Safety Evaluation Report

NUREG-0011

**Sequoyah Nuclear Plant
Units 1 and 2**

Docket Nos. 50-327
50-328

Figure 2-3

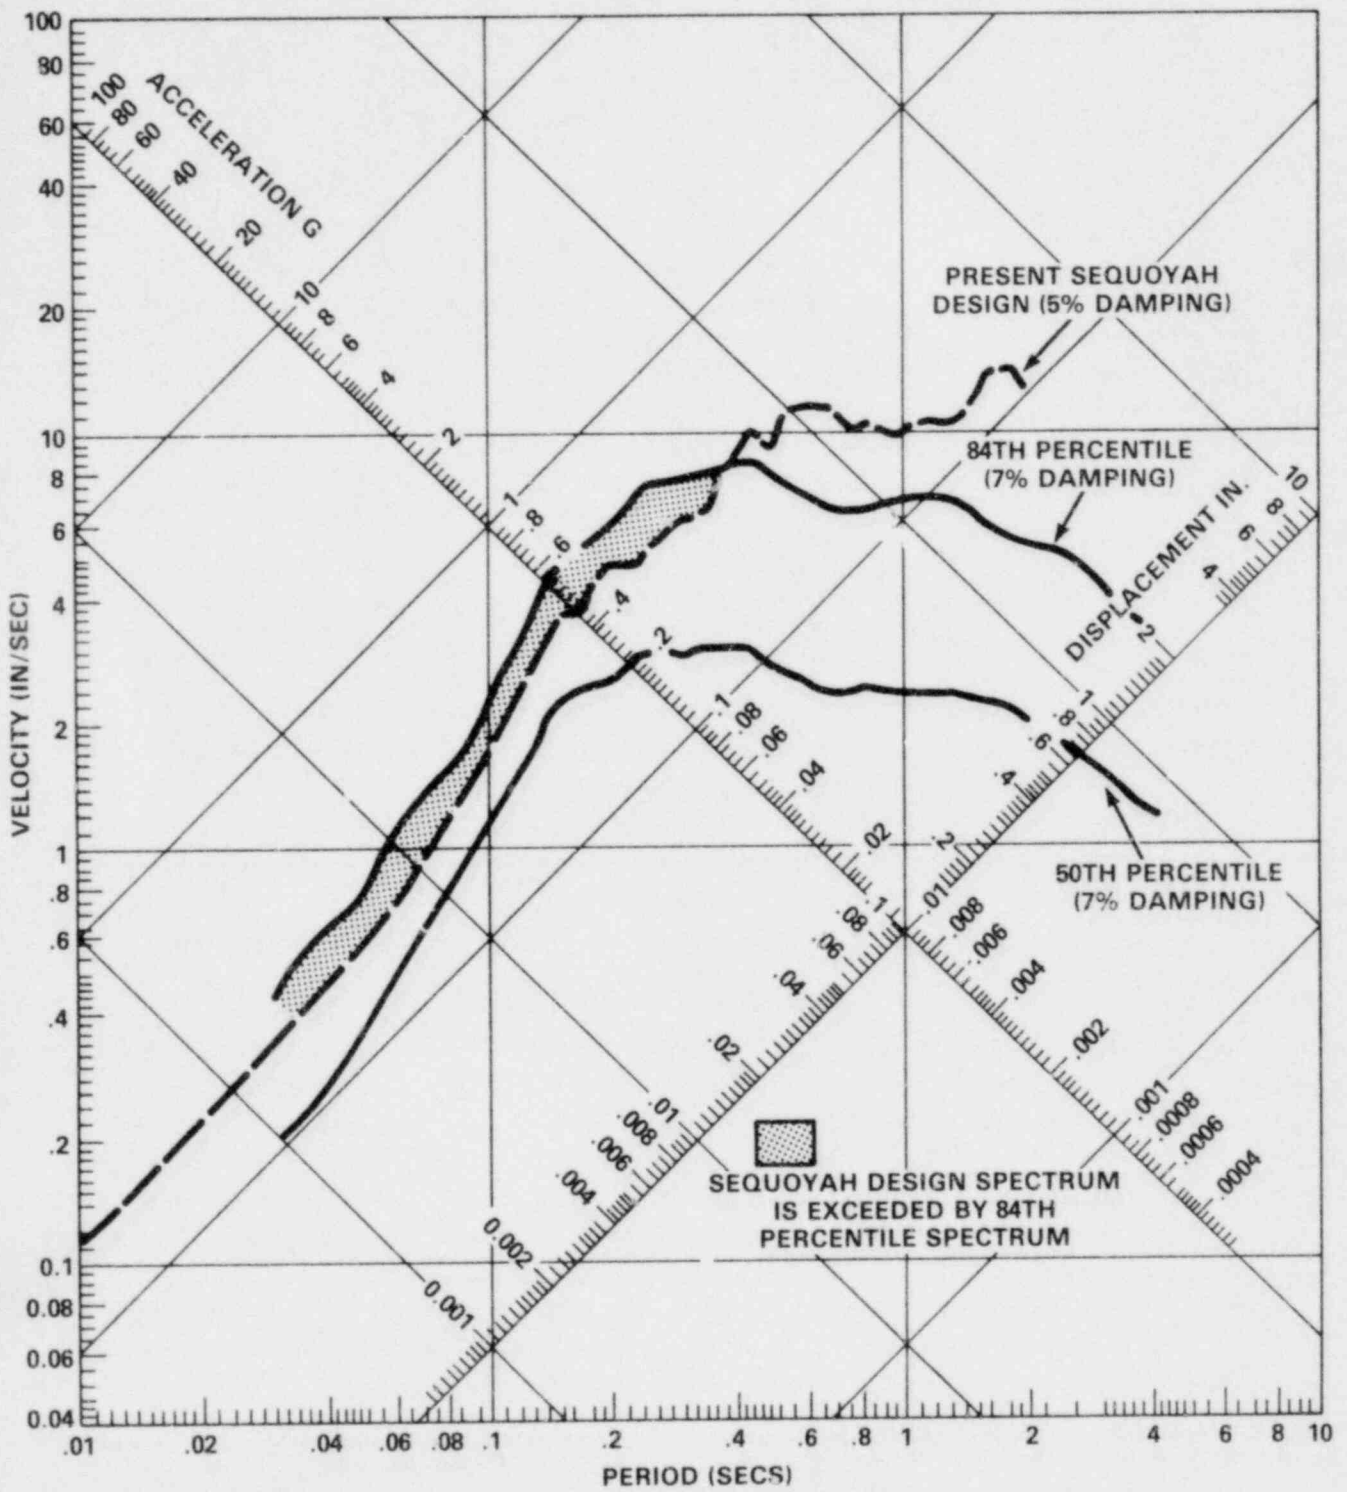
For periods of interest (less than 0.5 seconds), the present Sequoyah design spectrum for reinforced concrete lies between the 50th and 84th percentile (see Figure 2.3). The average in this period range is about the 74th percentile. The greatest departure from the 84th percentile is at 0.06 seconds (15 Hertz) where the present design is at the 67th percentile. In terms of actual spectral response for this period, the present design is at 0.18g while the 84th percentile (hereafter called the site-specific safe shutdown earthquake) would be at 0.28g. At periods greater than 0.35 seconds, the present design always exceeds the site-specific safe shutdown earthquake. Examination of other materials indicate less deviation of the present design from the site-specific safe shutdown earthquake. For welded steel, for example, the present design is less than the site-specific safe shutdown earthquake only at periods less than 0.08 seconds with the greatest departure being at 0.05 seconds (74th percentile). In terms of peak acceleration, the 84th percentile site-specific spectrum is associated with a peak acceleration of 0.215g.

The applicant contends that site-specific spectra should be chosen using the same procedures as those used in deriving the Regulatory Guide 1.60 spectrum and in the

Figure 2-4

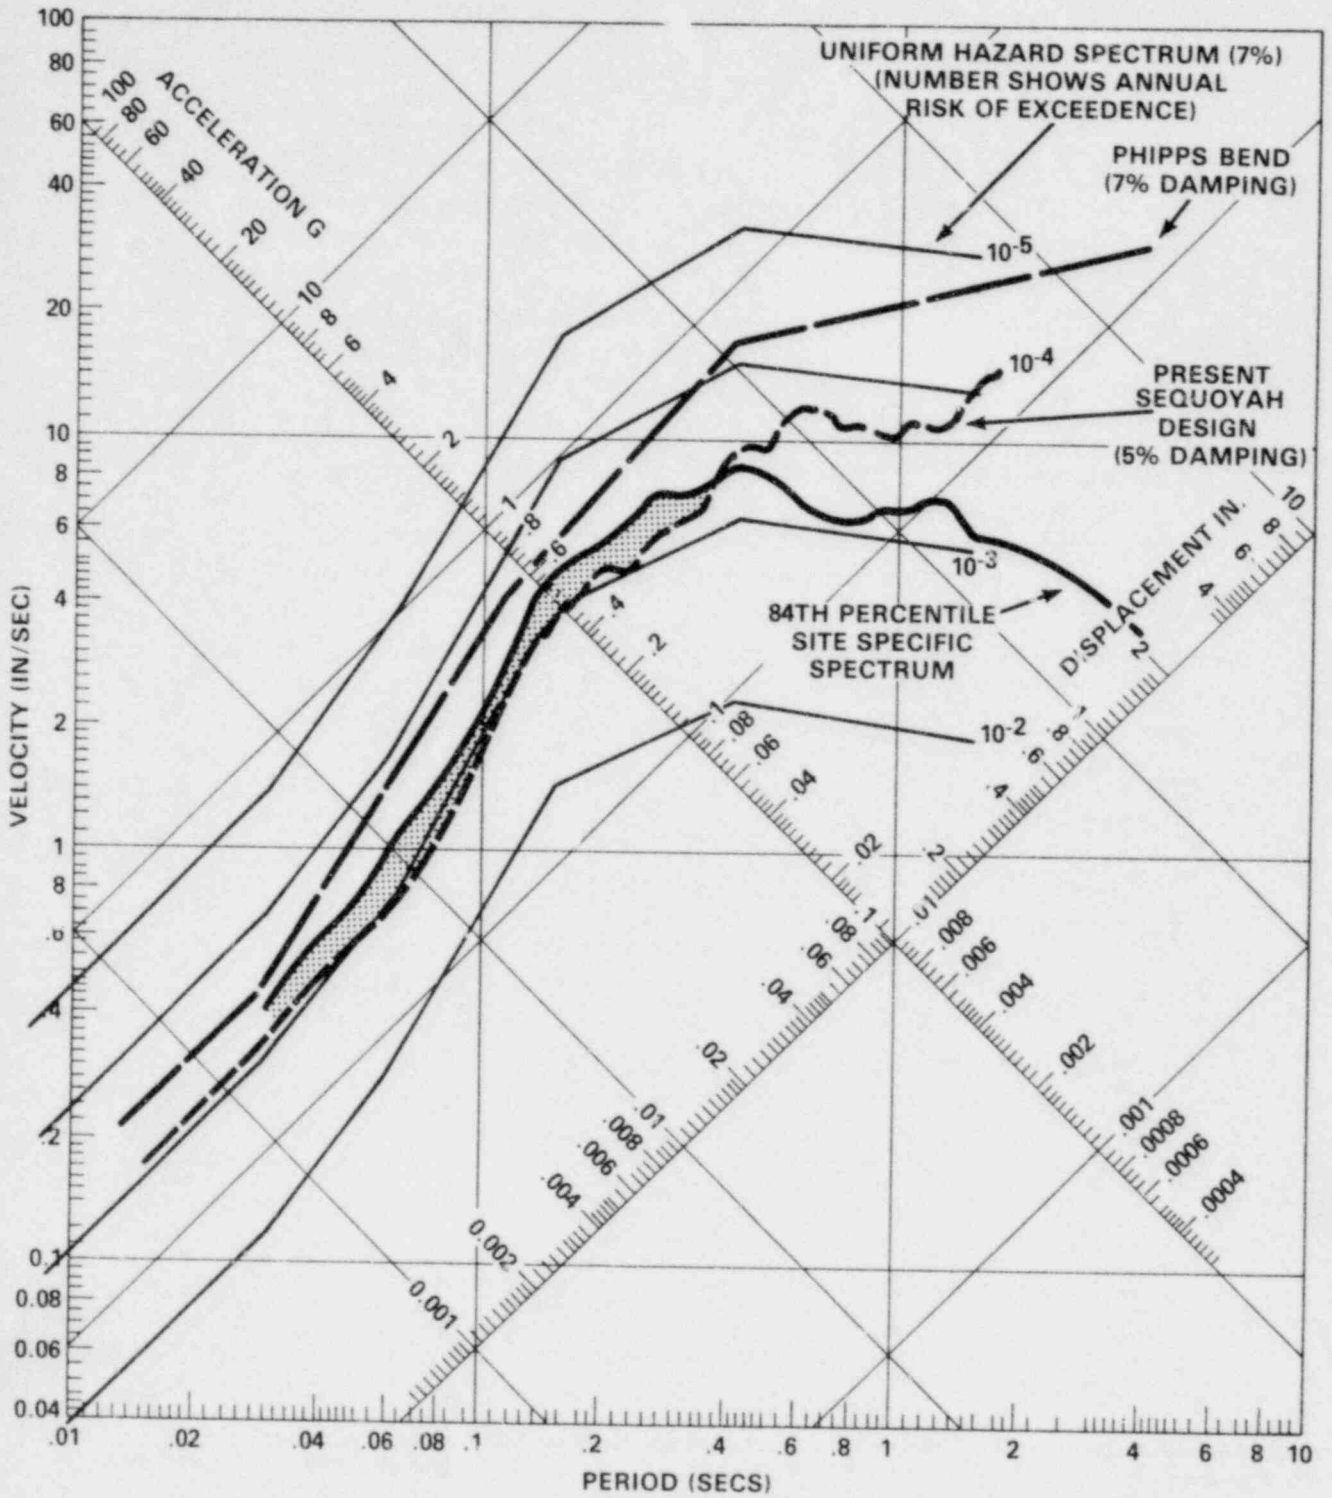
Simplified uniform hazard spectra were computed. These are spectra that have a uniform risk of exceedance, for example, 10^{-2} , 10^{-3} , 10^{-4} or 10^{-5} per year. They were compared to the present design spectrum, the site-specific safe shutdown spectrum, and the Phipps Bend safe shutdown earthquake spectrum which utilized the Regulatory Guide 1.60 response spectrum anchored at 0.25 g (see Figure 2-4). At periods of interest, the present design spectrum was found to be approximately equivalent to the 10^{-3} spectrum (average risk of exceedance at 9.0×10^{-4} per year). Both the site-specific and Phipps Bend spectra were found to lie between the 10^{-3} and 10^{-4} uniform hazard spectra with average risks of exceedance of 4.7×10^{-4} per year and 2.3×10^{-4} per year, respectively. This range (10^{-3} to 10^{-4}) is the general level of annual risk of exceedance of intensity VII-VIII or VIII calculated for various locations in the eastern United States (see for example McGuire, 1977).

Relative seismic hazard (ratios of annual risk of exceedance) were calculated for the different design spectra in the periods of interest. The seismic hazard associated with the present Sequoyah design is on the average twice as great as that associated with the site-specific safe shutdown spectrum. The "worst" case is at 0.06 seconds where the increase in hazard is a factor of 3.1. These relative hazards are very stable. Parametric tests indicated that while changes in recurrence rate, intensity cutoff and attenuation functions could result in variations greater than an order of magnitude in absolute seismic hazard, the relative seismic hazard changed very little.

Figure 6-1 Containment Pressure - Double Ended Pump Suction Break

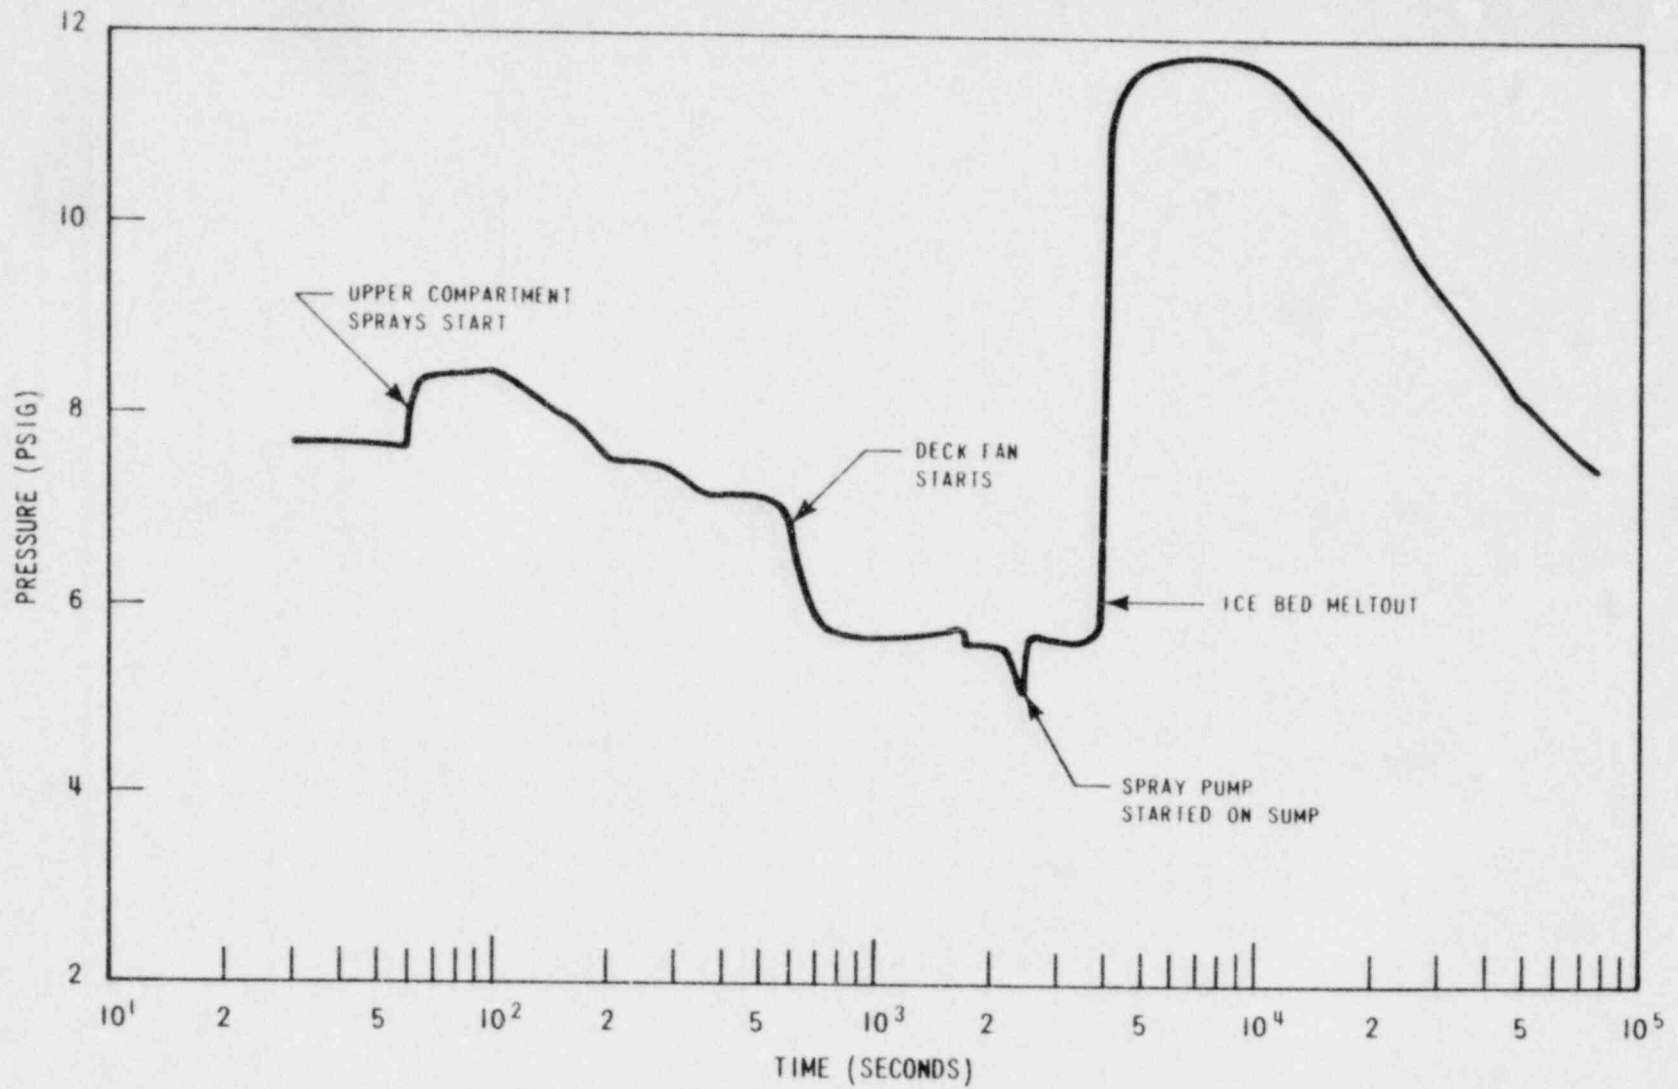
As seen in Figure 6-1, the containment spray system is activated after the completion of blowdown; i.e., about 30 seconds after accident initiation, and causes a slight reduction in the containment pressure. After about 10 minutes, the return air fans are started and the containment pressure is reduced to approximately 5.5 pounds per square inch gauge as air is returned from the upper volume to the lower volumes. Steam from the reactor coolant system is still being removed almost entirely by the stored ice at this time. After ice meltout, which occurs about 66 minutes after the accident, steam from the reactor coolant system is removed by the containment spray system. The containment pressure will again peak about two hours after the accident, at which time the energy input equals the minimum heat removal capability of the sprays. The magnitude of this peak pressure is determined by the heat input rate to the containment and heat removal rate of the containment spray system.
